Task Force Planning Priorities - Task 1: Prepare Updated Surface Water Monitoring Program for TDS/N for the Santa Ana River Reaches, 2, 3 ,4 and 5

## **Overview of Recommended Surface Water Monitoring Plan**

June 22, 2022

# 2022 Santa Ana River Water Quality Work Plan

## Slide 7

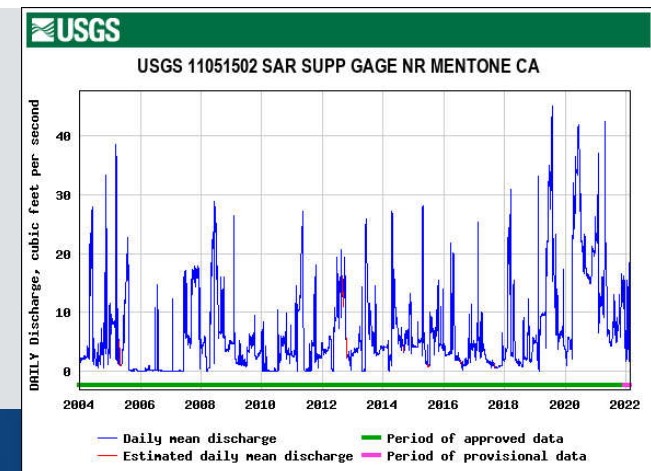
Drop in TIN plot

## Slide 8

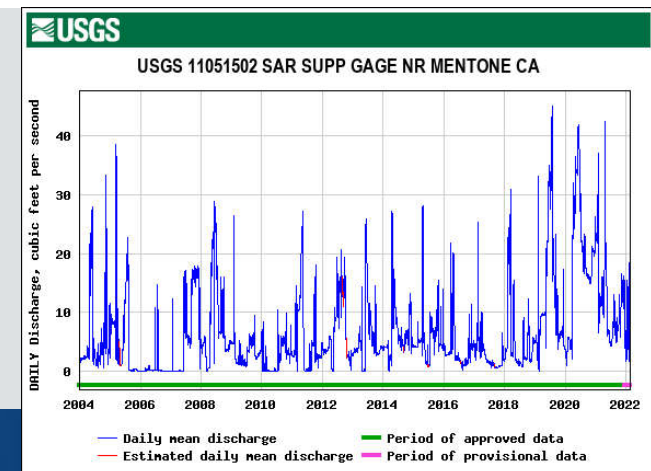
**SA0** This is not a data gap. This is just a fact. Suggest to delete.  
Samantha Adams, 2022-06-21T02:02:32.645

**SA0 0** Fourth bullet, I mean on Reach 5 losing reach  
Samantha Adams, 2022-06-21T13:01:45.227
